Access Compliance Report

Public Rights-of-Way

(Curb Ramps)

Intersection ID: 45541	Main Street: PEACHTREE_RD	Cross Street: HARRIER_RD	Location: SE
ADA ID: 5CEEED726C7F	Ramp Type: PerpDiag	Initial Pass/Fail: Fail	Overall Compliance: No
Severity Score: 10			
Codes/Mitigation Info/Possible Solution		Field Measurements/Component Compliance

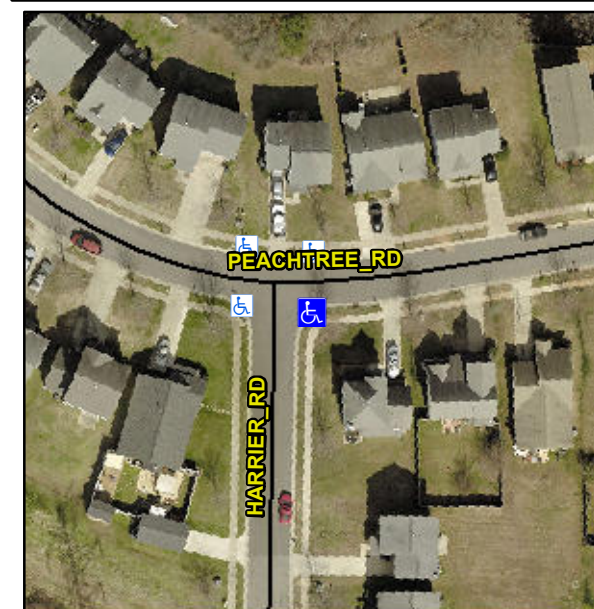
R304.5.1, R304.5.3

Compliance	Description	Data	Compliance	Description	Data
N/A	Ramp Length (in)	47.0	Yes	Ramp Slope (%)	5.6
No	Ramp Width (in)	46.0	No	Ramp XSlope (%)	2.9
N/A	Flare Type LT	N/A	N/A	Flare Type RT	N/A
N/A	Flare Slope LT (%)	N/A	N/A	Flare Slope RT (%)	N/A
N/A	Flare Traversable LT?	N/A	N/A	Flare Traversable RT?	N/A
N/A	Landing Length (in)	N/A	N/A	DWS Provided?	N/A
N/A	Landing Width (in)	N/A	N/A	DWS Contrast?	N/A
N/A	Landing Slope (%)	N/A	N/A	DWS Length (in)	N/A
N/A	Landing X Slope (%)	N/A	N/A	DWS Full Width?	N/A
N/A	Landing Curb? (Y/N)	N/A	N/A	DWS Offset (in)	N/A
N/A	Shared Landing?	N/A			
N/A	Gutter Ponding?	N/A	N/A	Gutter Slope (%)	N/A
N/A	Gutter Lip Ht (in)	N/A	N/A	Gutter X Slope (%)	N/A
N/A	Painted X Walk1?	No	N/A	Painted X Walk2?	No
	X Walk 1 Direction	To N		X Walk 2 Direction	To W
N/A	X Walk 1 Width (in)	N/A	N/A	X Walk 2 Width (in)	N/A
	X Walk 1 Slope (%)	1.2		X Walk 2 Slope (%)	0.5
	X Walk 1 X Slope (%)	0.1		X Walk 2 X Slope (%)	1.5

Remove & Replace Curb Ramp With Two New Directional Ramps or Equivalent.
